**CITY OF FRISCO  
LEBANON ROAD IMPROVEMENTS AND FORCE MAIN  
MUNIS NO. 15608  
BID NO. 1704-071**

**ADDENDUM NO. 3  
JUNE 2, 2017**

**00 91 13        ADDENDUM No. 3**

NO. 1  
SHEET G-4  
SEQ. 4

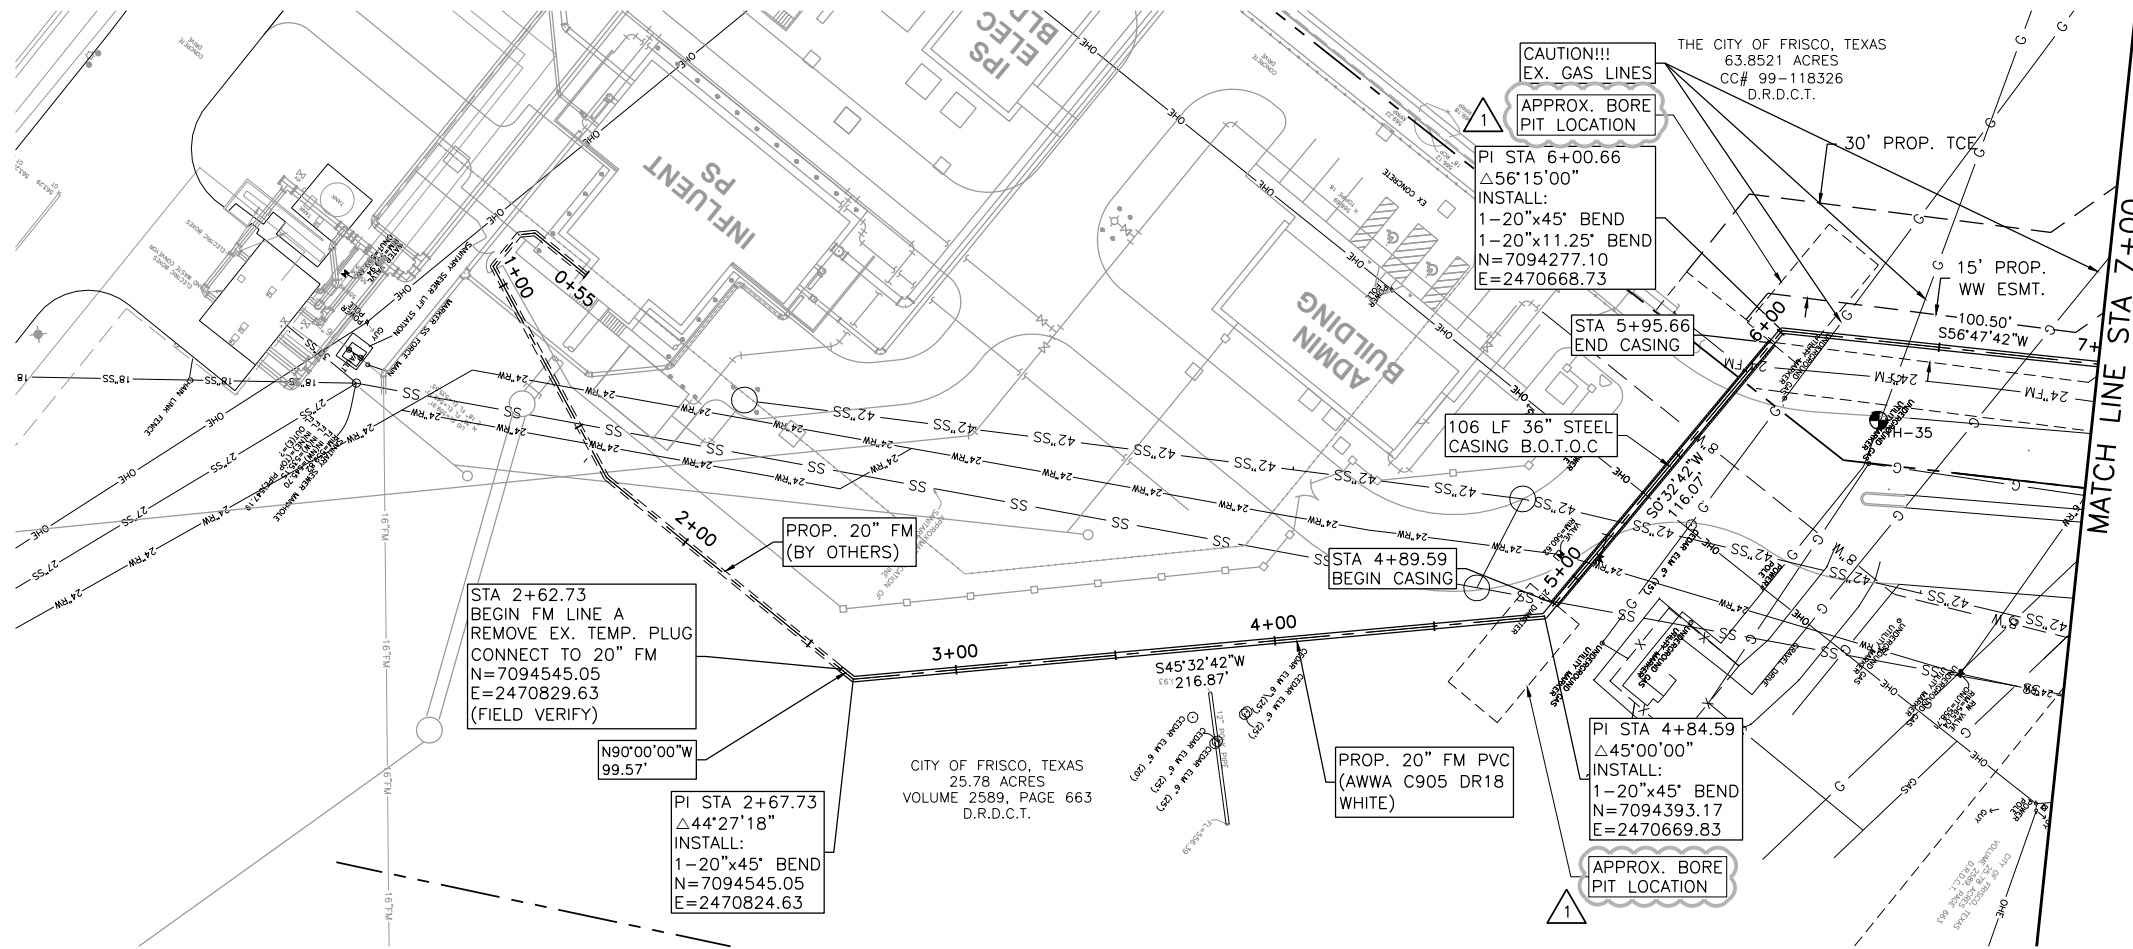
A3-8 Reference Sheet G-2, Seq. 2:

Modify FNI General Note 5 as follows: All disturbed areas along the force main outside of the Lebanon Road median shall have a 2' strip of sod installed along the one side of the easement line, as directed by the City, with hydraulic mulch covering all remaining areas. All seed and sod shall be planted and maintained per specification 32 92 23, Turfgrass Planting.

Add FNI General Note 9: Strip existing topsoil to a depth not to exceed 6" within the median and other areas of excavation activities. Replace with new topsoil once rough grading operations are complete. This work is to be considered subsidiary to the General Site Preparation.
